Wollongong Local Planning Panel Assessment Report | 29 May 2019

WLPP No.	Item No. 2
DA No.	DA-2018/1071
Proposal	Residential - demolition of garage and tree removals, Subdivision - Torrens title - two (2) lots, construction of dual occupancy on rear lot and Subdivision of dual occupancy - Torrens title - two (2) lots
Property	2 Coast Street, THIRROUL NSW 2515 – Lot 13 Sec O DP 5418
Applicant	Mr Russell Brown, Mrs Carni Brown and Mr Steven Arnold
Responsible Team	Development Assessment & Certification – City Wide Planning Team (RT)

ADDENDUM REPORT

PROJECT: 2 COAST STREET THIRROUL			
Drawing Name: LANDSCAPE PLAN	Job No. DML 17/028	Dwg.No. L-01	
CLIENT: ARNOLD AND BROWN	Scale 1:250 (A3)	Date 17/07/18	Rev. C

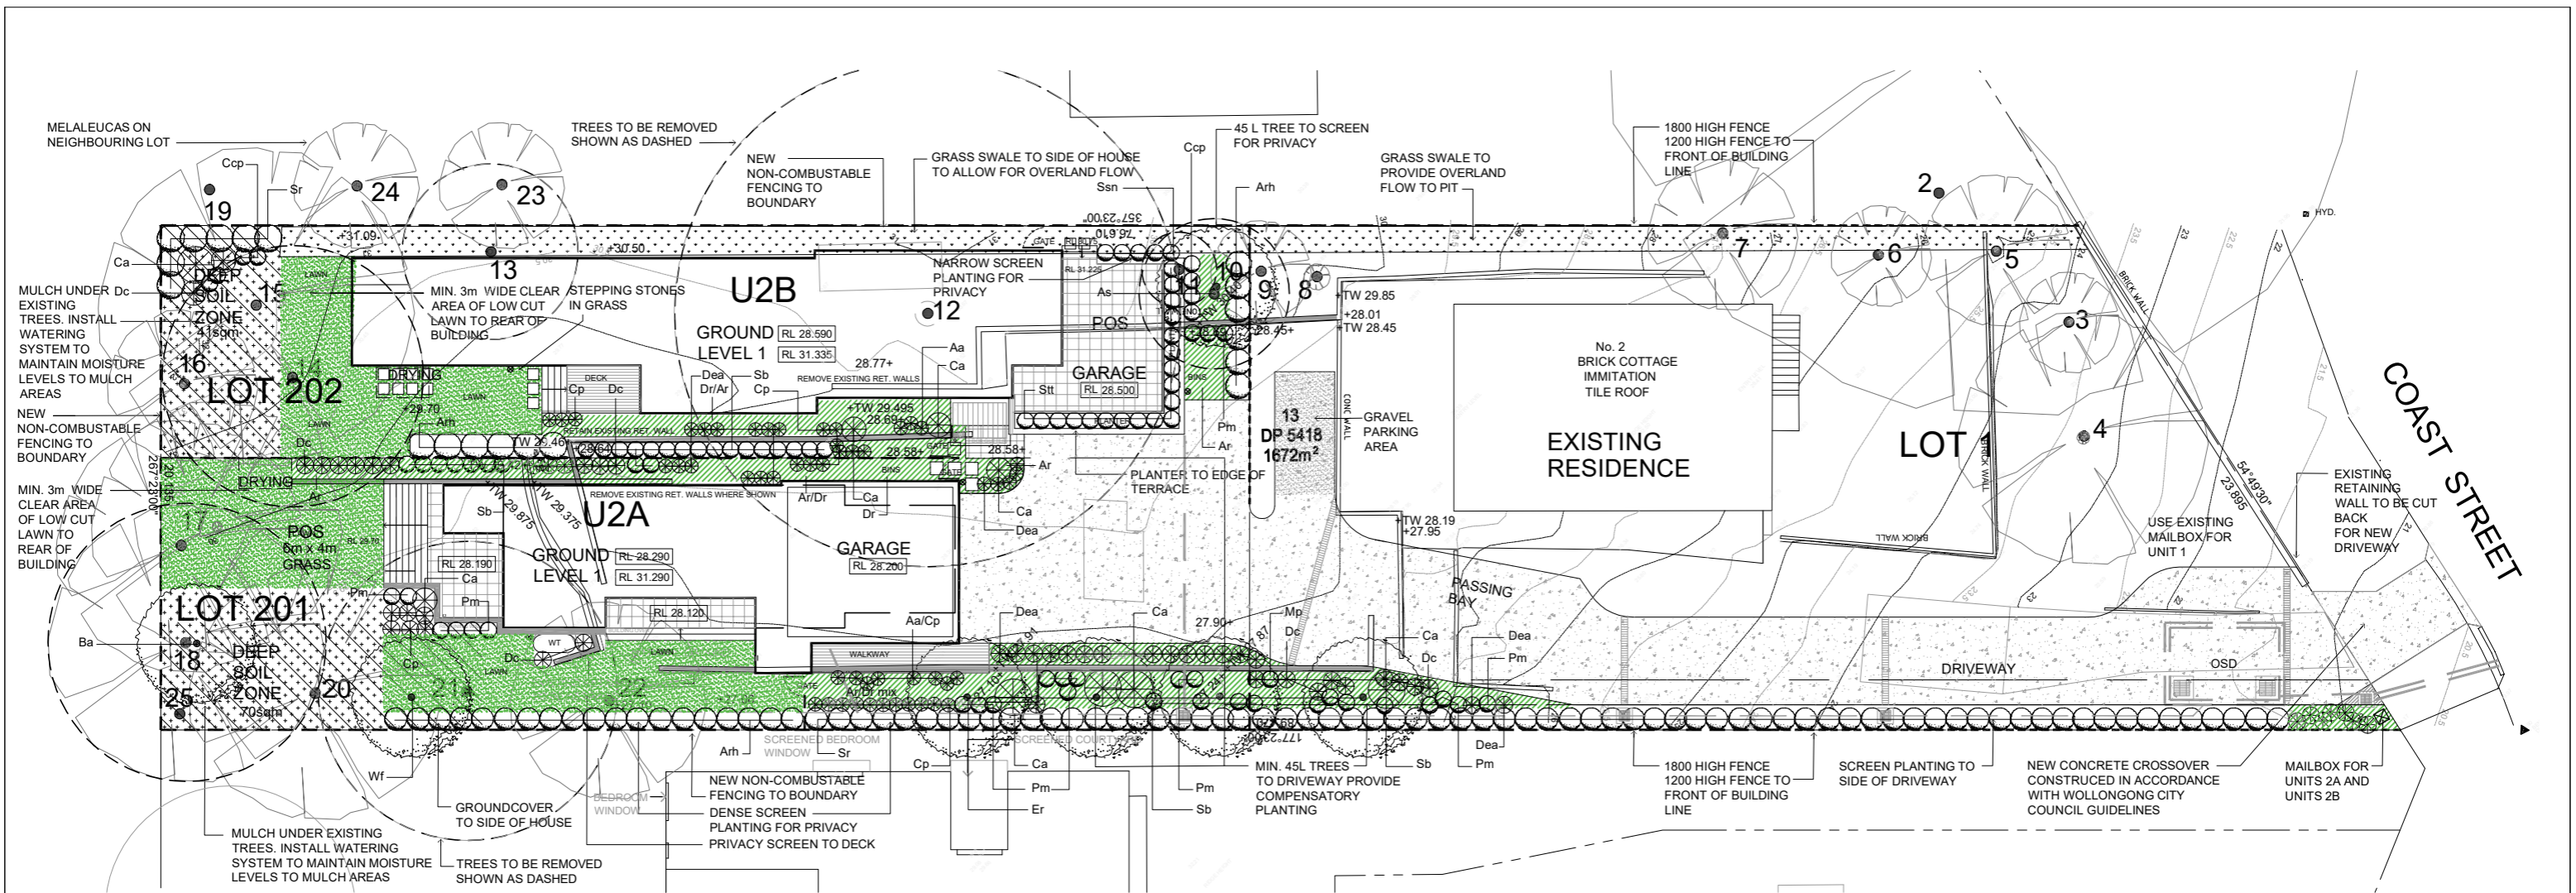
Condition 18 – The proposal provides planter boxes to the eastern and northern side of the Private Open Space terrace. This was requested by Council to protect the privacy to the existing residence. A planter box has not been provided on the western façade of the POS deck as the proposal provides more substantial screen planting at natural ground level where the terrace is as close as practicable to ground level (approx. 500mm above). The proposal also provides a 1.8m high screen fence to the western boundary which will ensure no loss of privacy to the adjoining neighbour. We request that council amend the condition to the developer must provide planter boxes as indicate on plans.

Condition 38(a) – This condition requires a 1m wide turf strip to either side of the proposed driveway. The concept landscape plan provides screen planting between the proposed driveway alignment and the eastern boundary. This condition restricts this planting to grass only, we request that the provision of a 1m wide turf strip be removed.

The resubmitted landscape plan also revises the trees to be removed to accommodate the revised design.

Trees to be removed are trees 10, 11, 12, 13, 14 & 21. Permission is also sought to remove tree 18 which is dead and neighbours have requested its removal due to safety concerns.

- Condition 18 'Provision of Planter Boxes' revised to require planter boxes along the Northern and Eastern edges of terrace for Unit 2B;
- Condition 23 'Landscaping' delete sub point 'g - an area of private open space to be developed for Unit 2A associated with living spaces;'

- Condition 26 'Compensatory Planting' revised to require four (4) replacement trees.
- Condition 38 revised sub point a to read as follows:
 - 'a. A minimum of 3.0 metre wide with a 1m landscaping strip along the Eastern side and a 1m turf strip along the Western side.'

Figure 2. Site Cross Section – 16a Seafoam Avenue indicated as 'Adjoining residence'.

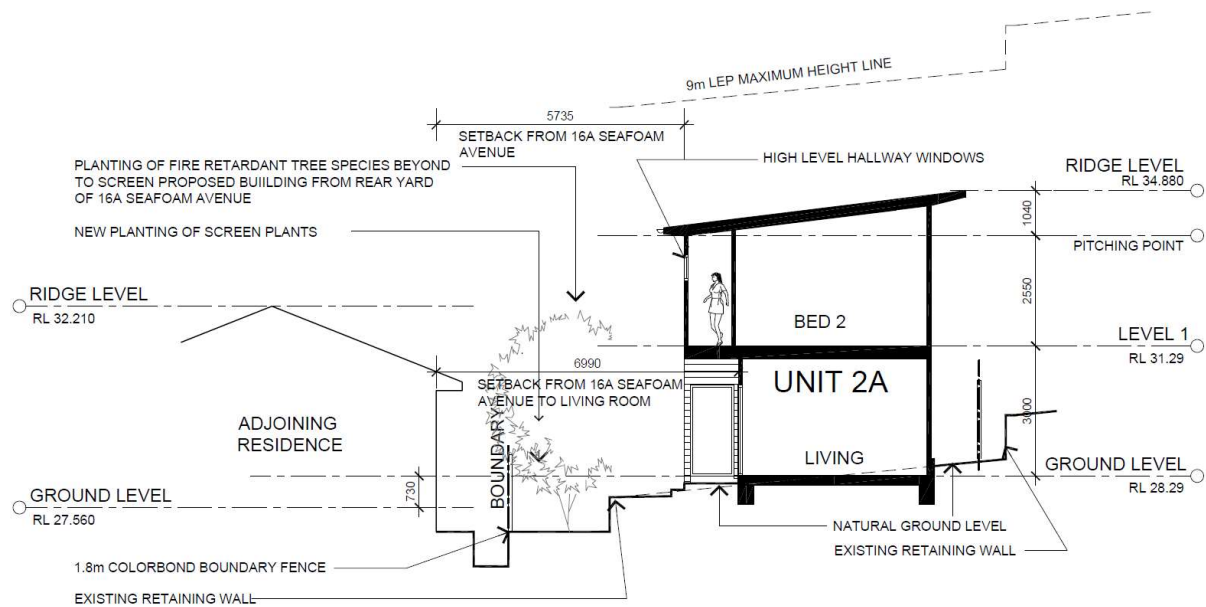
Refer to **Figure 2** which indicates proximity of 16a Seafoam Avenue to the proposed residence.

Figure 3. Location of two storey area over garage and store room – Unit 2B

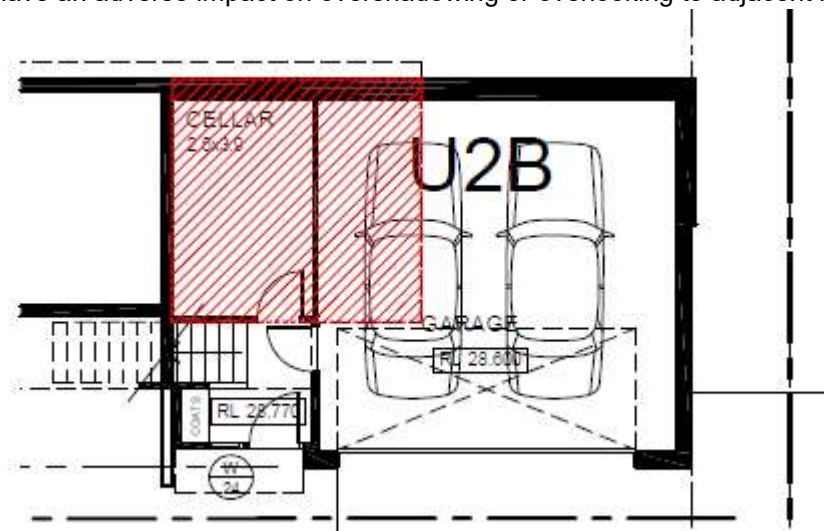
Unit 2B has a portion of habitable areas located over the non-habitable store room and the garage. The design takes advantage of the site slope which falls approx. 2.4m over the 7.5m building zone. (Refer to **Figure 3** for area of encroachment.) enabling parking at the lower level and habitable floor levels located close to natural ground level on the western boundary.

The design has been incorporated to integrate the building into the natural landform and does not have an adverse impact on overshadowing or overlooking to adjacent lots.

Figure 4. Location of windows with potential to overlook 16a Seafoam Avenue

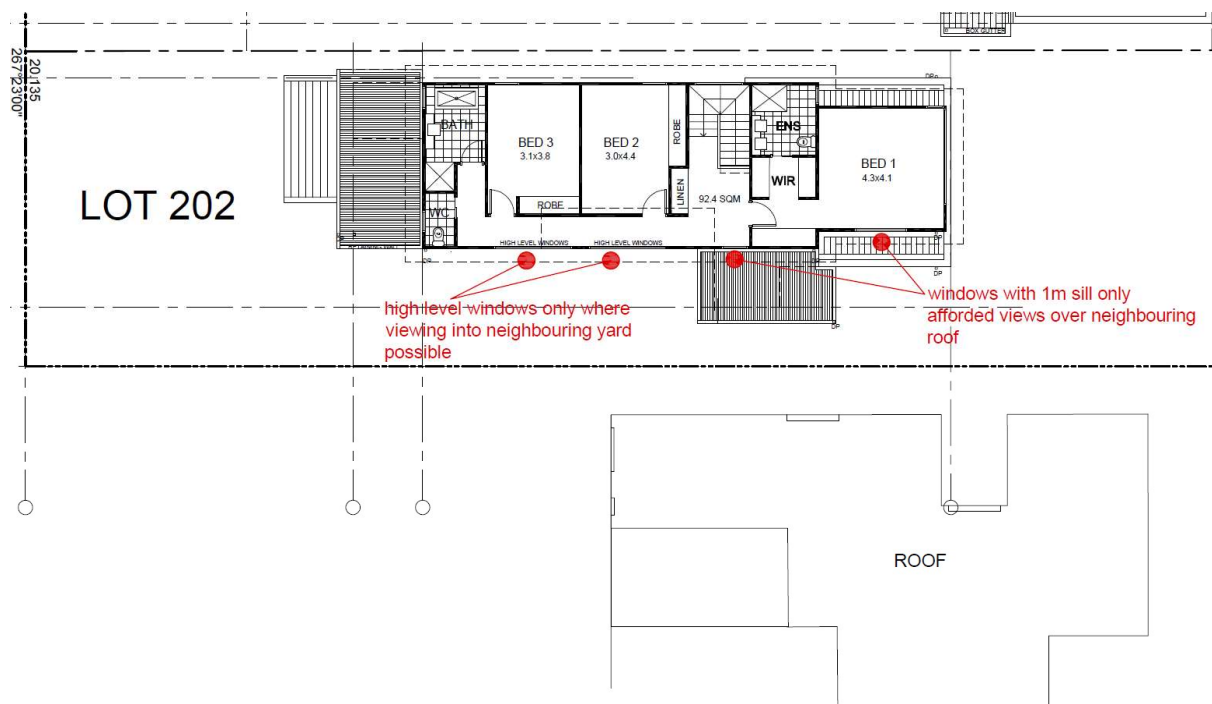
These sympathetically located windows ensure that any potential for overlooking to the neighbouring dwelling and the rear open space area has been mitigated.

Refer to Figure 4 for window locations.

Figure 3: Extent of side setback variation highlighted in yellow.

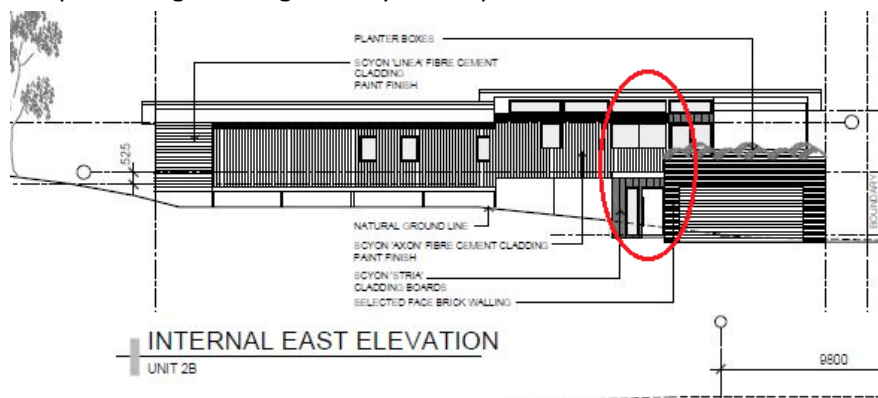
- The proposed development will have minimal impact on the adjoining dwellings in terms of overlooking for the following reasons:
 - The upper level windows on the eastern elevation of Unit 2A consist of highlight windows within the hallway and bedroom window. Windows on the upper level of the rear elevation consist of bathroom windows. Amended plans now indicate that the dining room window on the ground floor has been changed to highlight window so as to minimise overlooking impacts from higher usage areas.
